**Re: Approval of a Final Plat of a Major Subdivision known as Stoney Creek North Third Addition a 14 lot residential subdivision totaling 16.42 acres, more or less, legally described as part of the SE $\frac{1}{4}$ NE $\frac{1}{4}$  of Section 6 AND part of the NE $\frac{1}{4}$ SE $\frac{1}{4}$  of Section 6 in Pleasant Valley Township**

**Re: Agenda Item 5.: Resubmitted Item - Final Plat – Major Subdivision: Application from Tim Dolan DBA Stoney Creek North, LC, for a Final Plat of a Major Subdivision known as Stoney Creek North Third Addition located on two tracts of land ([Parcel# 850623008](#) ; [Parcel # 850639002](#)) totaling 16.42 acres, more or less, legally described as part of the SE<sup>1</sup>/<sub>4</sub>NE<sup>1</sup>/<sub>4</sub> of Section 6 AND part of the NE<sup>1</sup>/<sub>4</sub>SE<sup>1</sup>/<sub>4</sub> of Section 6 in Pleasant Valley Township. The proposed Plat would subdivide the existing tracts into fourteen (14) new lots and seven (7) outlots.**

PLANNING & ZONING COMMISSION  
STAFF REPORT  
November 5, 2019

# FINAL PLAT OF STONEY CREEK NORTH THIRD ADDITION TO SCOTT COUNTY, IOWA

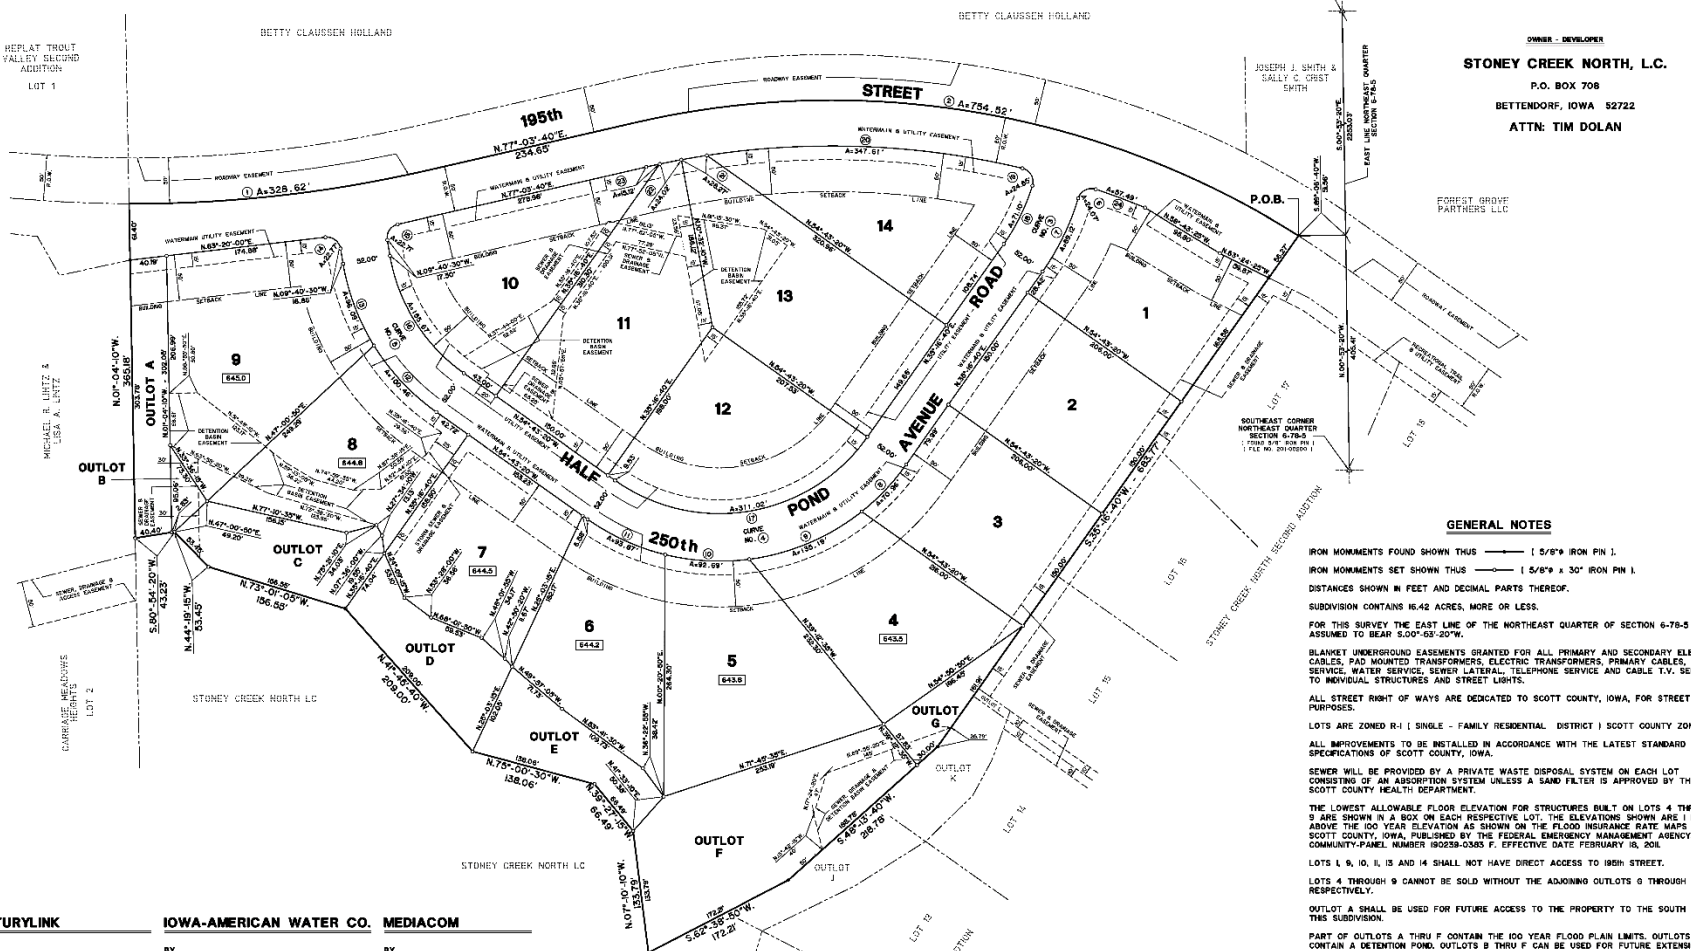
**GENERAL COMMENTS:** This request is for approval of a Final Plat for a 14 lot residential subdivision on a 39 acre parcel zoned Single-Family Residential (R-1). The property has frontage and access to Forest Grove Road. The Final Plat shows a loop street with two entrances to Forest Grove Road. The proposed street configuration has five (5) lots inside the loop and the remaining nine (9) lots on the exterior of the loop. Lots range in size from 0.69 acres to 1 acre. The property is adjacent to Stoney Creek North II to the east, Carriage Meadows Heights to the west, and Spencer Creek Estates to the south. The original Stoney Creek Subdivision, with 29 residential lots, is located south and east of this property.

The Final Plat does show seven (7) outlots (A-G) ranging in size from 0.04 acres to 0.96 acres. Part of outlots A through F contain the 100 year flood plain limits. Outlots F and G contain a detention pond. In addition, Outlots B through F can be used for future extension of sanitary sewer along Spencer Creek.

**STAFF REVIEW:** Staff has reviewed this request for compliance with the requirements of the Subdivision Regulations and the Zoning Ordinance for Final Plat approval. All of the proposed lots exceed the minimum lot size required by Health Department Regulations and the R-1 zoning district requirements. The plat does make provision for access through this property to the adjacent undeveloped land to the southwest. However, development of that area would require construction of a bridge across Spencer Creek. Outlot A is intended to allow the future extension of a shared driveway to the property when a bridge is constructed.

Both Stoney Creek North and Stoney Creek North II had loop streets with a single intersection to Forest Grove Road. As stated above, the current configuration would have two intersections with Forest Grove Road. All lots will only have access to the interior loop road. The lots that are also adjacent to Forest Grove Road will not be permitted to have direct access on to this County Road. The road would adhere to the Rural Address System and be named 250<sup>th</sup> Avenue.

The County Engineer also had comments regarding the maximum grade of the subdivision road shown as 8%. SUDAS preferred maximum is 5% but cites 12% as acceptable. Thus the 8% is acceptable but not recommended because it can cause issues in slippery driving conditions.

The Subdivision regulations require all internal street to be adequately drained and that detention facilities adequate to capture the runoff from a one hundred (100) year rain event at post-developed flows shall be place in the subdivision. The release rate from that detention area shall not exceed the volume produced by a five (5) year event calculated at pre-developed flows. The County Engineer has reviewed the stormwater management plan and found them to comply with the requirements of the ordinance. In addition, the County Engineer would like to see the covenants indicate who is responsible for maintenance of the detention ponds and the storm sewer outlets.

The applicant proposes to serve the lots with water from the Iowa American water system which is currently located along Forest Grove Road. This will also allow the subdivision to be served with fire hydrants. The City of Bettendorf stipulated in its approval the location and spacing of those hydrants.

Spencer Creek runs along the south boundary of this property. The limits of the designated 100-year floodplain are shown on the Final Plat in outlots A through F. Outlots B through F can be used for future extension of sanitary sewer along Spencer Creek.

However a 15 foot wide pedestrian trail and utility easement is shown in the Final Plat along the north boundary of the subdivision, adjacent to the County road (195<sup>th</sup> Street) easement extending along the north boundary. This would allow pedestrian access between the three subdivisions without residents having to go out onto the County road. The developer previously has constructed a pedestrian bridge over Spencer Creek for access between the two subdivisions, Stoney Creek and Stoney Creek North.

**RECOMMENDATION:** Staff recommends that the Final Plat for Stoney Creek North Third Addition Subdivision be approved with the following conditions:

1. The City of Bettendorf review and approve the Final Plat;
2. The County Engineer review and approve all street construction plans prior to construction
3. The plat note reading, "All Street R.O.W. be dedicated to Scott County, Iowa, for street purposes" be removed prior to recording as recommended by the County Engineer.
4. The covenants include provision for private road maintenance ; and
5. The subdivision infrastructure improvements be completed or a surety bond posted prior to Final Plat approval.

# FINAL PLAT OF STONEY CREEK NORTH THIRD ADDITION TO SCOTT COUNTY, IOWA

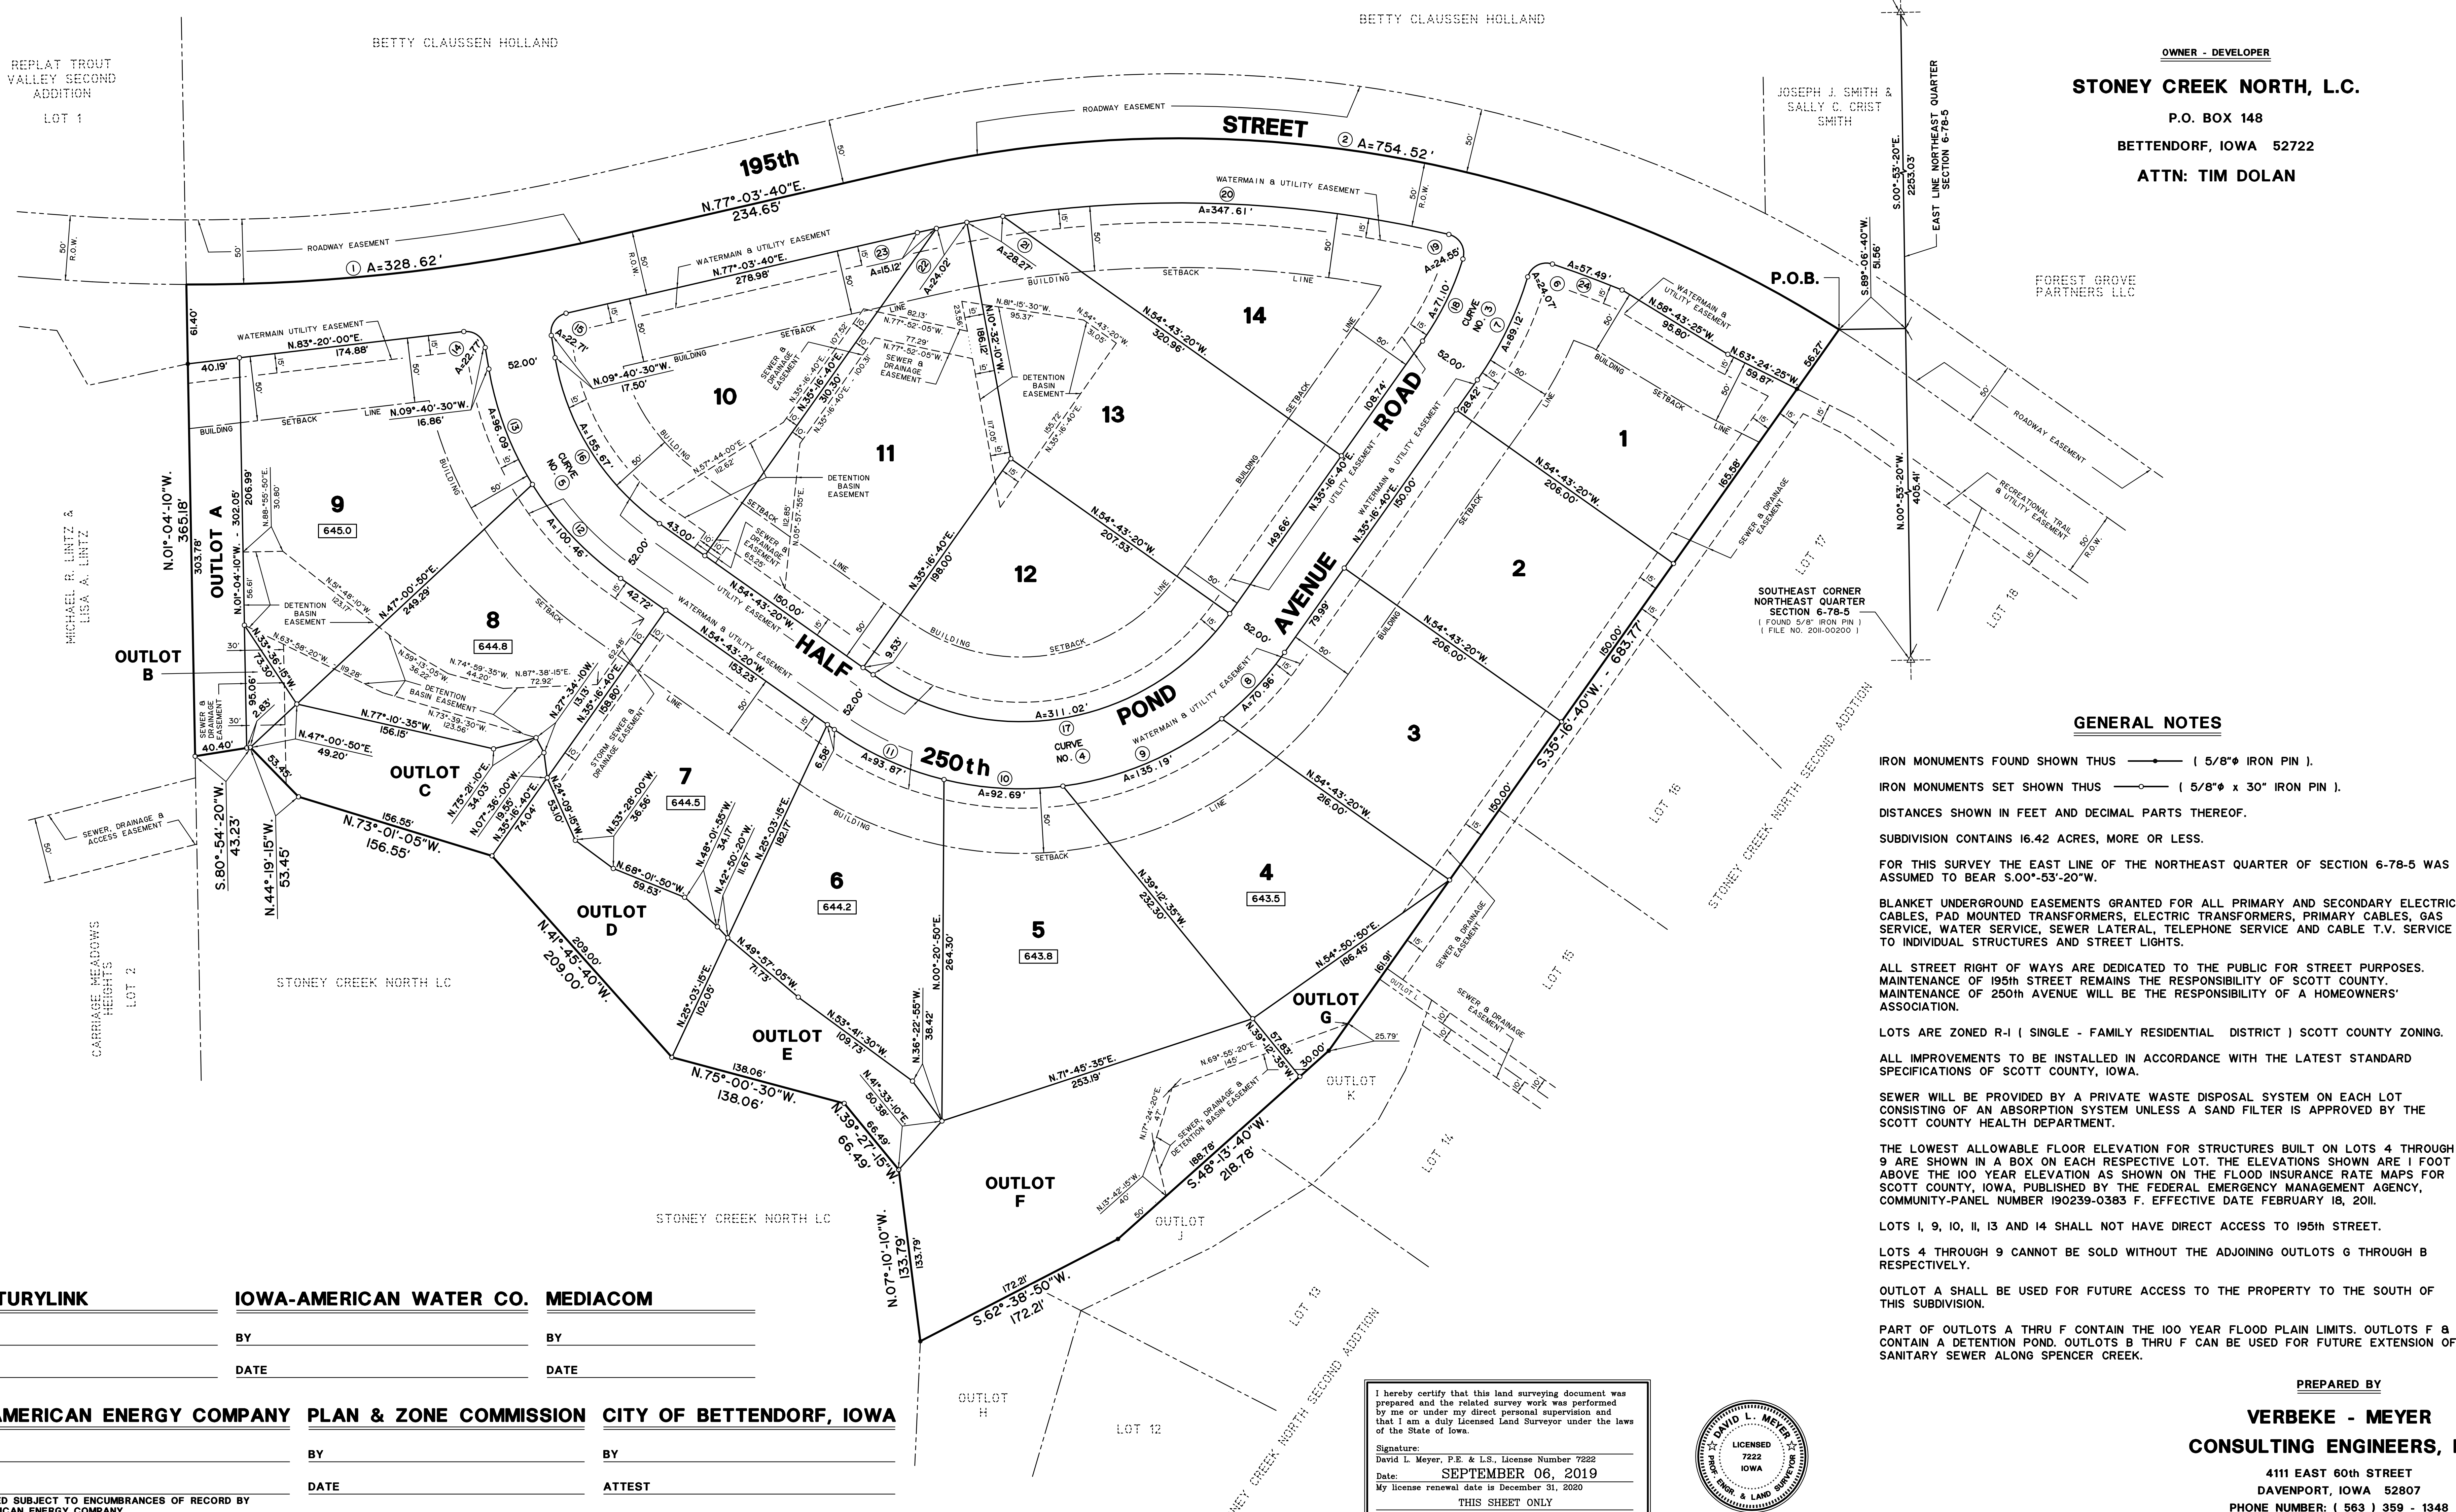
This recommendation of the Planning Commission expired sixty (60) days after the November 5<sup>th</sup> meeting when the required platting documents were not submitted. This necessitated another review and renewal of the Planning Commission's recommendation which is on its September 1<sup>st</sup> agenda. Staff would expect a favorable recommendation to approve. Staff has determined that all of the conditions included with previous recommendation have been met. The County Engineer stated that all the construction inspection documentation for the project has been received and that the road construction has been completed and all work has been performed in reasonable compliance with the plans and specifications with one exception. The proposed sidewalk along the south right-of-way line of 195th Street connecting the Stoney Creek subdivisions has not been installed and will be constructed by the developer or Home Owners Association at a future time.

- ALL STREET RIGHT OF WAYS ARE DEDICATED TO THE PUBLIC FOR STREET PURPOSES. MAINTENANCE OF 195th STREET REMAINS THE RESPONSIBILITY OF SCOTT COUNTY. MAINTENANCE OF 250th AVENUE WILL BE THE RESPONSIBILITY OF A HOMEOWNERS' ASSOCIATION.
